## DEPARTMENT REPORT

SUBJECT: H-2025-0002

Rockwell Neighborhood

Annexation of 51.15 acres of land with the R-15 zoning district; a preliminary plat consisting of 412 building lots, 26 commons lots; and alternative compliance to the city's standards for developments abutting a state highway.

## E. Landscape Plan (date: 3/5/2025)

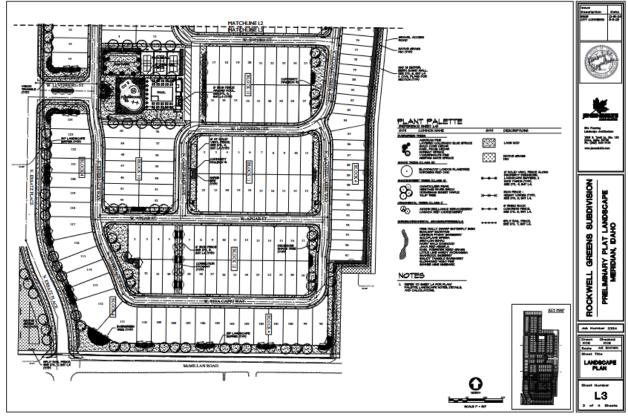
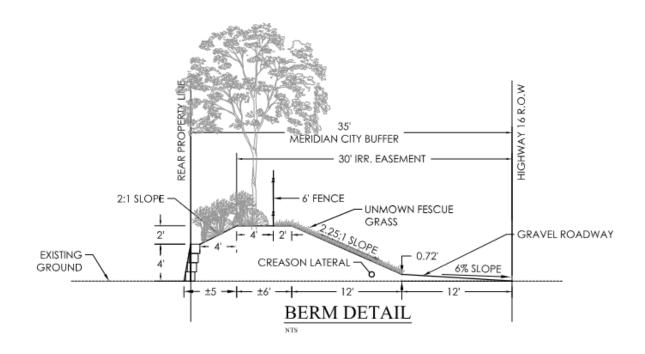
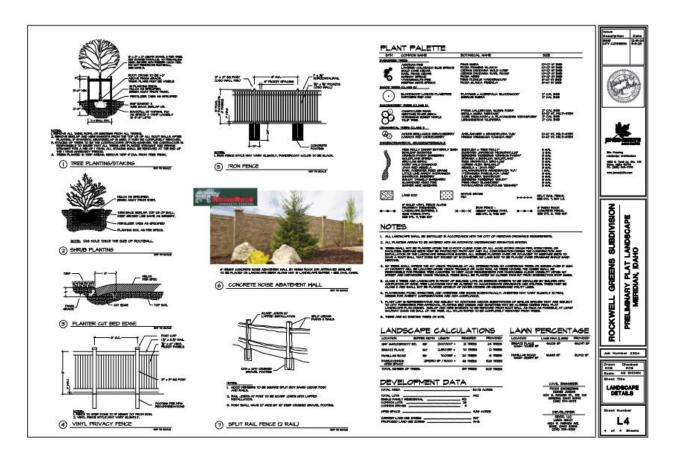
The applicant has provided landscape buffers in compliance with UDC 11-2A-7. However, the ten (10) foot multi-use pathway along McMillan Road shall be detached from the roadway with landscaping in the parkway. This shall be revised with the final plat. Additionally, to meet the Fields Sub Area Plan, staff is recommending split rail fencing be included in the planter along McMillan Road and Ersatz Place, to match what the applicant has proposed in Lot 29, Block 8.

The landscape buffer along SH-16 is required to be thirty-five (35) feet; however, a thirty (30) foot irrigation district easement encumbers thirty of the thirty-five feet. The applicant has submitted a detail of the landscaping and berm along SH-16. The applicant shall enter into a license agreement with Nampa Meridian Irrigation District to landscape the first four (4) feet behind the wall depicted in the exhibit or provide an additional four (4) feet of landscaping outside of the easement to allow for eight (8) feet of landscaping on the backside of the wall. In addition to this, the applicant has requested alternative compliance to the standards of UDC 11-3H-4 for developments along State Highways. In this request, staff is recommending one tree every twenty (20) feet instead of one every thirty-five (35) feet and 80% vegetation coverage along SH-16 to help with sound attenuation and air quality.

All fencing is required to comply with the standards listed in UDC 11-3A-7. According to the submitted landscape plans, the applicant is proposing three types of fencing throughout the site, vinyl solid fencing, split rail, and wrought iron semi-privacy fencing. The applicant is proposing an eight (8) foot fence around the pool, which is not in compliance with the UDC. The maximum fence height in a residential district is six (6) feet in height. This revision shall be revised with the final plat.

- 3. The landscape plan submitted with the final plat shall include the following revisions:
  - a. Include mitigation calculations on the plan for existing trees that are proposed to be removed in accord with the standards listed in UDC 11-3B-10C.5. The Applicant shall coordinate with the City Arborist (Kyle Yorita <a href="https://kyorita@meridiancity.org">kyorita@meridiancity.org</a>) to determine mitigation requirements prior to removal of existing trees from the site.

- b. Provide one (1) tree within every residential lot (approximately every twenty-eight (2028) feet) along State Highway 16 to help mitigate for sound attenuation and air quality. In other open spaces along State Highway 16, provide trees every twenty (20) feet.

- d. Widen the multi-use pathways along N. Ersatz Pl to ten (10) feet as required by the pathway master plan.
  - e. Provide split rail fencing in the planters along W. McMillan Road and N. Ersatz Place to match the split rail fencing proposed in Lot 29, Block 8.

- g. Provide details on the type and location of shrubs, ornamental grasses, and perennials that will be used.
  - h. Provide a pedestrian connection to W. McMillan Road through Lot 108, Block 4 in alignment with the pedestrian connection located on Block 12.

- i. Provide a pedestrian connection in the form of a micro pathway in a minimum of a fifteen (15) foot common lot in accord with UDC 11-3A-8 through Lot 2215, Block 8 and Lot 3643, Block 8 in alignment with the proposed sidewalks along the west side of N. Camp Creek Avenue to provide better connectivity for the residents in the northern portion of the subdivision with the primary open space and amenities.

- j. The applicant shall enter into a license agreement with Nampa Meridian Irrigation District to landscape the first four (4) feet behind the wall abutting SH-16 as depicted in the irrigation easement or provide an additional four (4) feet of landscaping outside of the easement to allow for eight (8) feet of landscaping on the backside of the wall.

- k. Remove the northernmost entrance along N. Ersatz Place in alignment with W. Snow Currant Street to be in compliance with UDC 11-3A-3, and replace it with a micro path lot
